Minutes of the Special Meeting of the Albany County Airport Authority

**January 23, 2020
 Special Meeting**

- 1. Authorization of Contracts/Leases/Contract Negotiations/Contract Amendments**
 - 1.1 Change Order No. 3: Authorization to award Change Order #3 to Contract # 989-PC New Parking Garage Precast to Unistress Industries.**

1.2 Change Order No. 4: Change Order #4: Authorization to award Change Order #4 to Contract # 989-GCr New Parking Garage General Construction to LeChase Construction Services, LLC

Drawing No.  
**E-002**

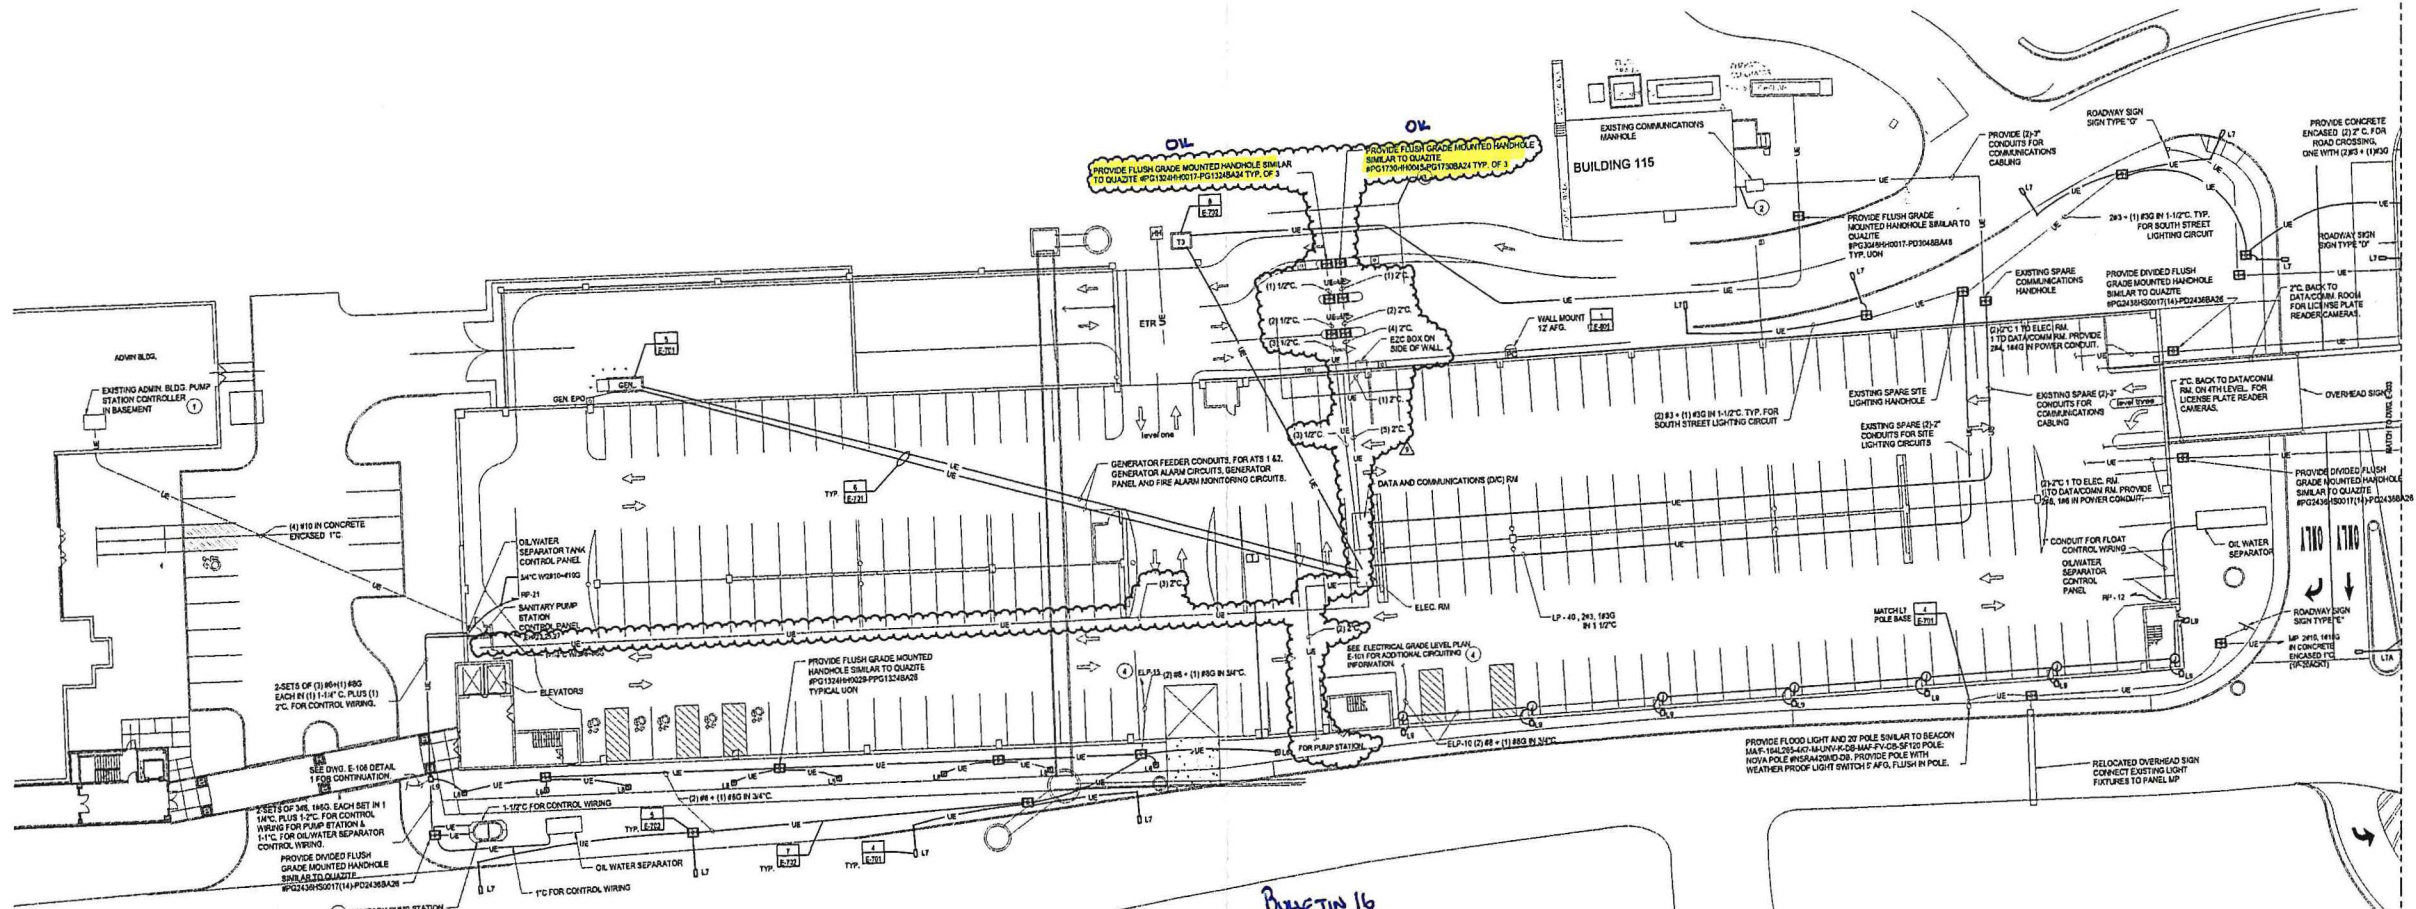
Description of Change: PCO 030 - Bulletin 16-Changes-Provide additional underground conduits as indicated on attached Electrical Drawing E-002.

- PROVIDE DETAIL BACK UP FROM ELECTRICAL SOB
- DELETE MOUNT R2C - SHOWN ON PREC DRAWINGS (VERIFY FIELD LOCATIONS)
- CONDUIT FOR RAMP SECTION NOT CORR DRILLED
- TRENCHES ALREADY OPEN - WITH ADDITIONAL TIME/COSTS
- WHERE IS 1/2" CONDUIT TO EAST CONDUIT - NOT ON COR COVER SHEET

Provide additional underground conduits as indicated on attached Electrical Drawing E-002.

1. Provide all backup, lump sum not acceptable.
See attached backup.
2. Delete mounting of EZC box, this will be mounted in Parcs contracted package.
Mounting of EZC removed from Proposal.
3. Conduit for pump station not core drilled.
Core drill conduit removed from proposal.
4. Where is 1/2" conduit to east canopy, this is not called out on COR cover sheet.
*1/2" Conduit going out to PARCS was changed to 1" by ATI prior to this drawing being released.
All conduits under slab was already 1" so it was continued out to the hand holes as this size.*

1. Trenches already open- why additional time/costs.
The trenches were not already open. We spent 2-3 days the week of 11/4/19 finalizing the Parcs system to these islands. There was additional time coordinating scope that was poorly detailed in the bid documents. There was additional time setting handholes, than adjusting the hand holes 2 different times, because CHA provided us with a preliminary bulletin drawing and then the Parcs team provided us with what would be the final layout drawing in the field.

- INSTALL 368FT * 2 - 2" SCH80 PVC (PUMP STATION) - UNDERGROUND (This was never on original drawings) *Agree*
- INSTALL 100FT * 3 - 1" SCH80 PVC (PARKS 1) - UNDERGROUND (This was never on original drawings) *Agree*
- INSTALL 80FT * 5 - 2" SCH80 PVC (PARKS 2) - UNDERGROUND (Everything on the original drawings that says 1-1/2" was changed to 2" by ATI) *Provide Credit For 1 1/2" Conduit + Excavation - UNDERGROUND SLAB*
- INSTALL 3 - 13X24 HAND HOLE (This was never on original drawings) *Agree* *2" Conduit*
- INSTALL 3 - 17X30 HAND HOLE (This was never on original drawings) *Agree* *From Control Room To Cables*
- INSTALL 7 - 2" SLEEVES FOR PARKS (This was never on original drawings) *Agree*

2075-03

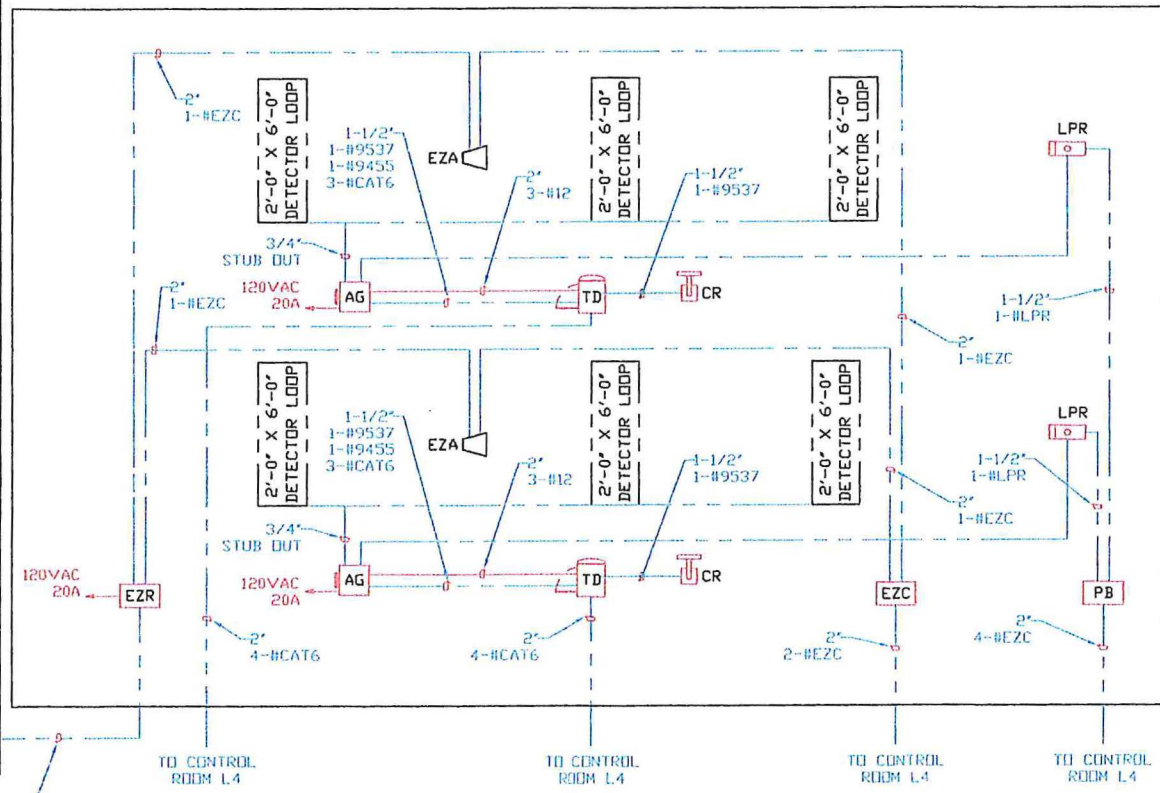
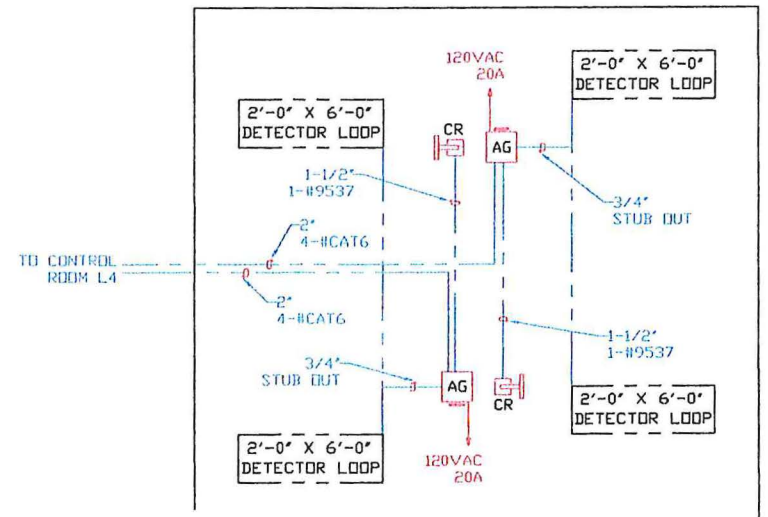
*Work shown on Armano McGinn Drawing 2078-03 included in Base Contract Work  
 Add should be increase in conduit size from 1 1/2" conduit to 2" conduit*

*A NOTE ON ARMANO MCGINN DRAWING 2075-03 INDICATES TO INSTALL PER CODE REQUIREMENTS  
 - ON SITE MEETING/CONFERENCE CALL INDICATED SEPARATE CONDUITS RATIO.*

DETAIL "B"  
 POURABLE SEAL  
 ARMORLESS BRIDGE JOINT SECTION  
 AT ABUTMENT  
 NOT TO SCALE

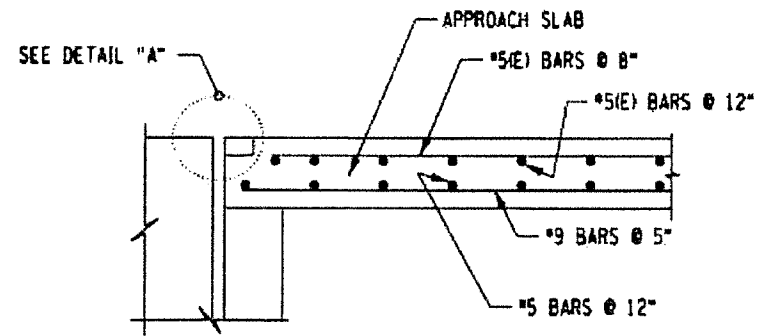
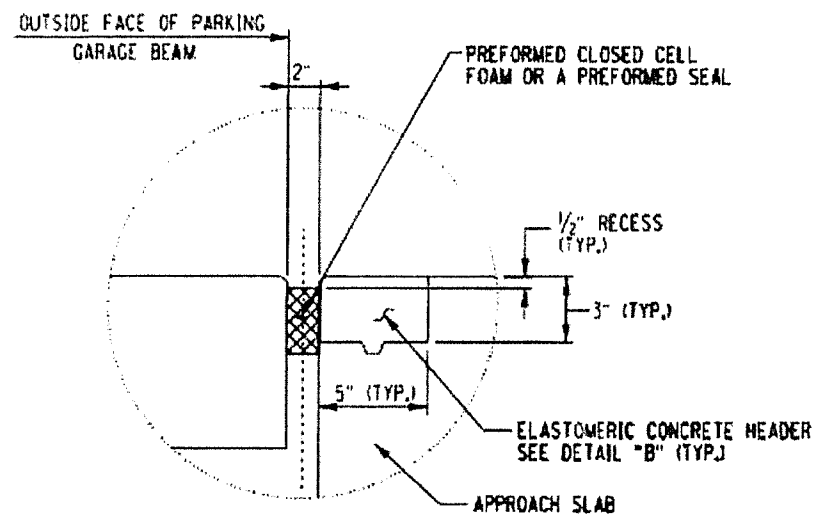
As for the joint material at the road surface, see the attached "joint detail 1" from ST-18. The plans call for preformed closed cell foam or a preformed seal. We will also accept the joint detail in the attachment called "Backer rod and sealant option." We agree that either of these options would be preferred at the horizontal roadway surface as well as the vertical joints on either side.

Drawing provided by Unistress for 4 possible locations of the Louver (L-1)

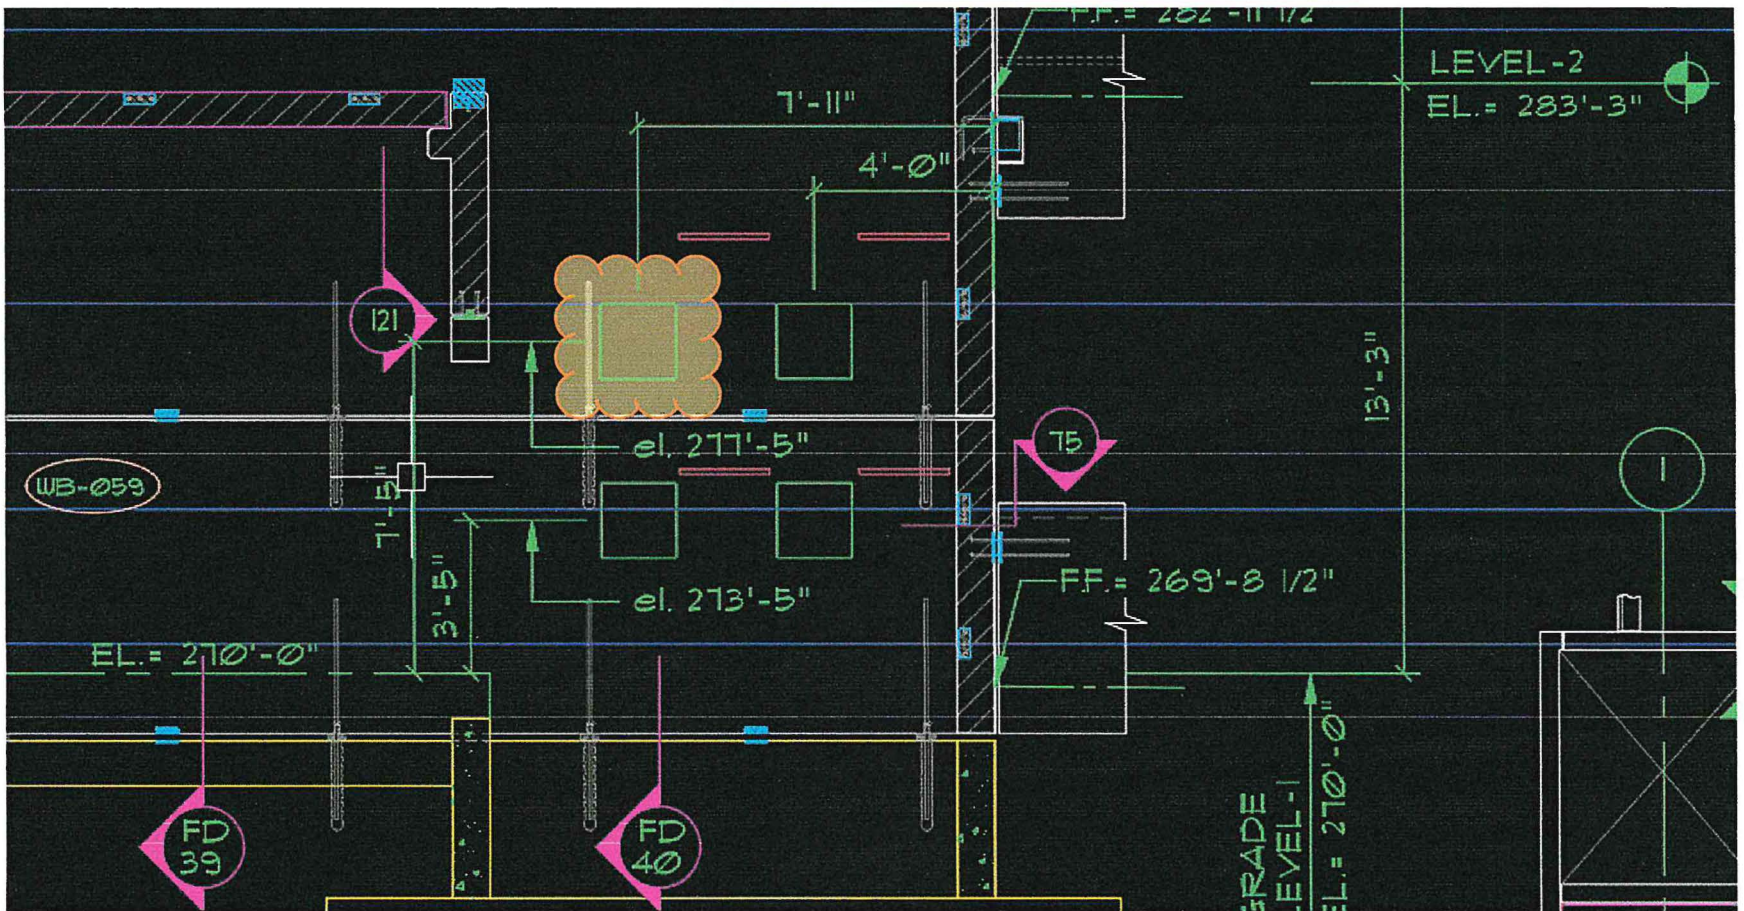
LeChase to coordinate and confirm with Kone the location of the L-1 louver, (3) EH-6 electric heaters and EF-1 exhaust fan.

Revision Dated: 11-25-19  
Revised By: JCCG  
LeChase to provide Louver in Location highlighted below. (West Side of Elevator Shaft 7'-5" from floor (EL. 270'-0") to center of opening)
